**DA 2020/450 - 36 Rous Mill Road Rous Mill -
 Locality Map**

ASSESSMENT OF THE APPLICATION UNDER SECTION 4.15 (1) OF THE EP& A ACT 1979**4.15 (1) (a) (i) - the provisions of any environmental planning instrument****Local Environmental Plans (LEPs)**

Figure 1 – GPRS Location Map

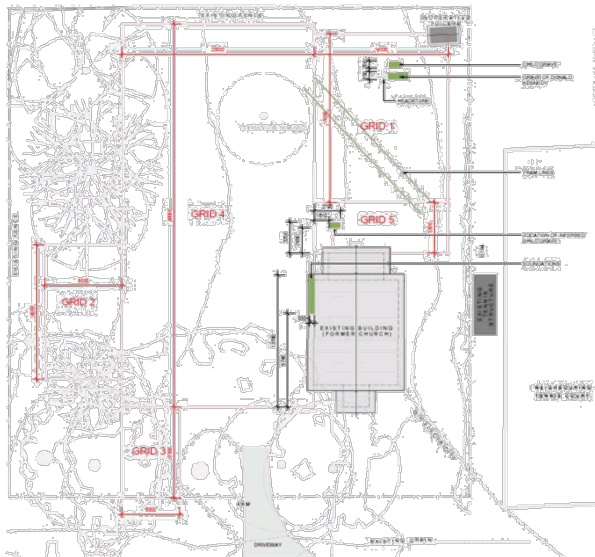
The report expanded upon an earlier prepared GPRS to investigate the subsurface of all the areas affected by the development and to establish if these areas contained burials, or other features of archaeological significance. The survey revealed one adult burial adjoining the Kennedy headstone, and two additional subsurface features which may be small child burials, all located in the north east corner of the site. The GPRS also discovered an unidentified rectilinear feature located to the west of the standing church building and two tracks which were interpreted to be residual tram lines from the sugar cane mill. Refer to Figure 1 below for the location of the identified subsurface features.

PROJECT	ADDRESS	CLIENT/SITE OWNER	TITLE	DWG NO.	ISSUE	DATE
Rous Mill Pottery Studio	36 Rous Mill Rd, Rous Mill, NSW, 2477	Ray Cavill	PROPOSED SITE PLAN	DA 10	C	15.01.2020

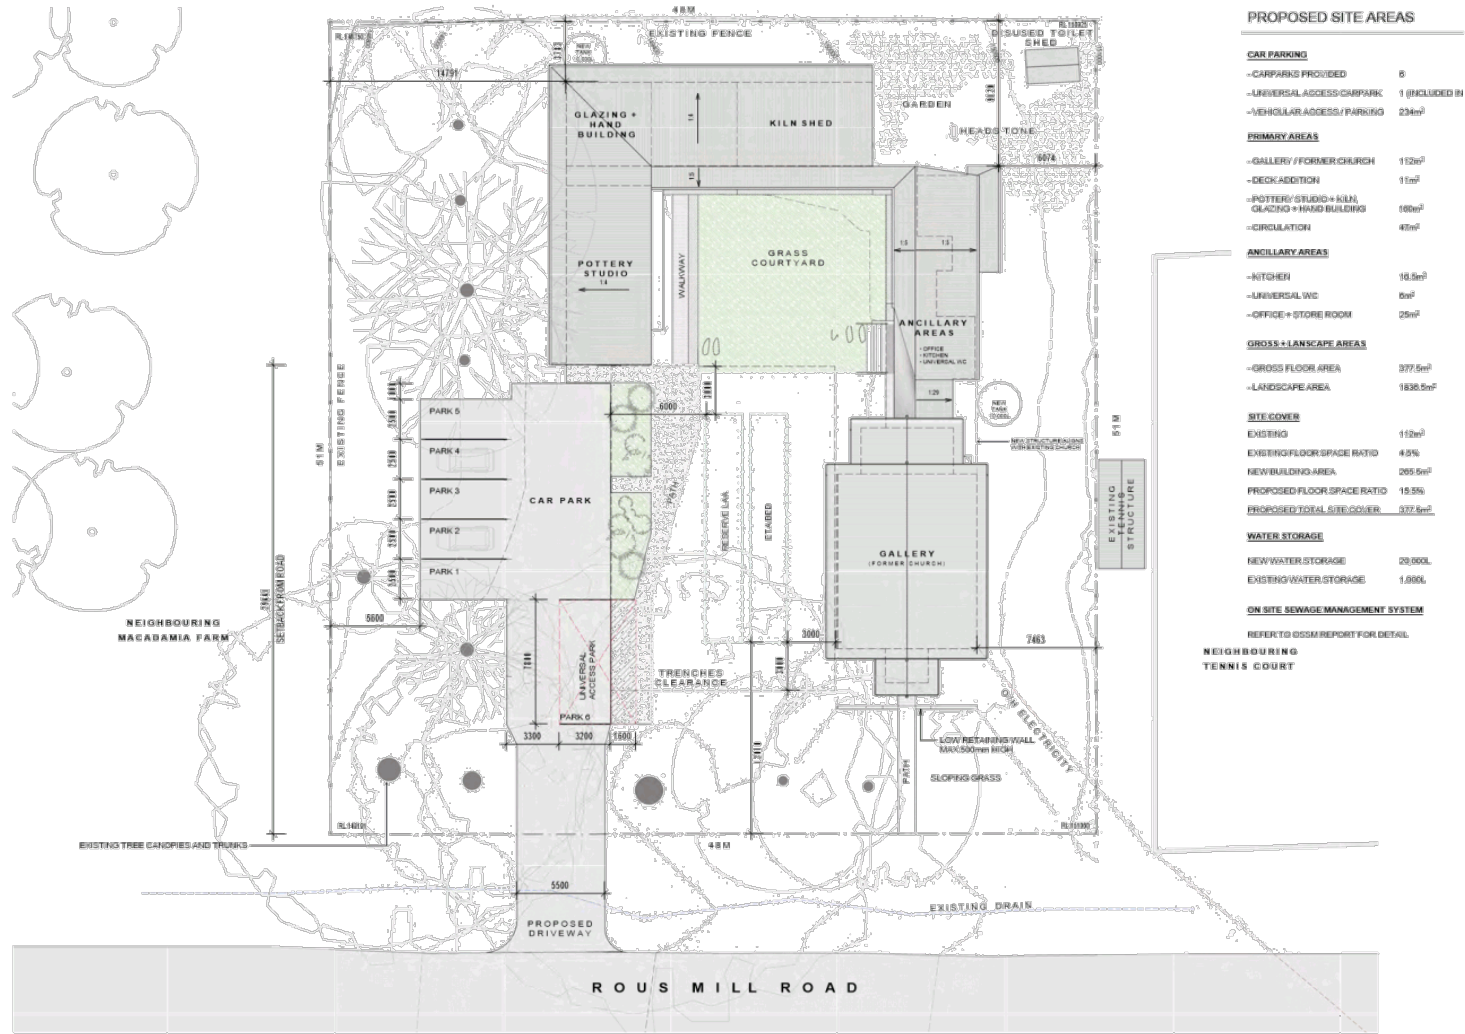
In respect to the on-site car parking numbers, there are no set car parking rates in the DCP for this type of development. The application proposes six onsite parking spaces. Based on the proposal details (refer to Council report) and the expected patronage details provided in the SEE, Council's Development Engineer has undertaken a merit assessment for car parking demand and determined that eight spaces are required, that is, two additional onsite parking spaces. These can be provided as all-weather gravel parking spaces except for the accessible parking space which is required to be sealed. This outcome is to be conditioned, with plans showing compliance to be submitted to Council prior to the issue of the Construction Certificate.

The proposed accessible parking space is located within the entry access way. The low level of vehicle movements would suggest this is reasonable, however the car space orientation does not allow for vehicles to enter and exit the site in a forward direction as no turn facility is provided. This space could be slightly repositioned and made perpendicular to the driveway to facilitate the ability to enter and exit the site in a forward direction. A suitable condition is recommended in this regard.

The development shall provide a minimum of **eight** parking spaces on-site which are constructed from all-weather dust free material. The design of all car parking and vehicular accesses are to be in accordance with the Australian Standard AS/NZS 2890.1:2004. Design plans are to be certified by a suitably qualified professional and approved by the Principal Certifying prior to issue of the Construction Certificate.

The design of the disabled car parking space is to be in accordance with Australian Standard AS/NZS 2890.6: 2009 and must be constructed from concrete or have a bitumen surface. The proposed accessible parking space (shown in Proposed Site Plan – DA 10 - Issue C – Dated 15.01.2020) is to be rotated to be perpendicular with the access driveway to allow entry and exit from the site in a forward direction. Design plans are to be certified by a suitably qualified professional and approved by the Principal Certifying prior to issue of the Construction Certificate.
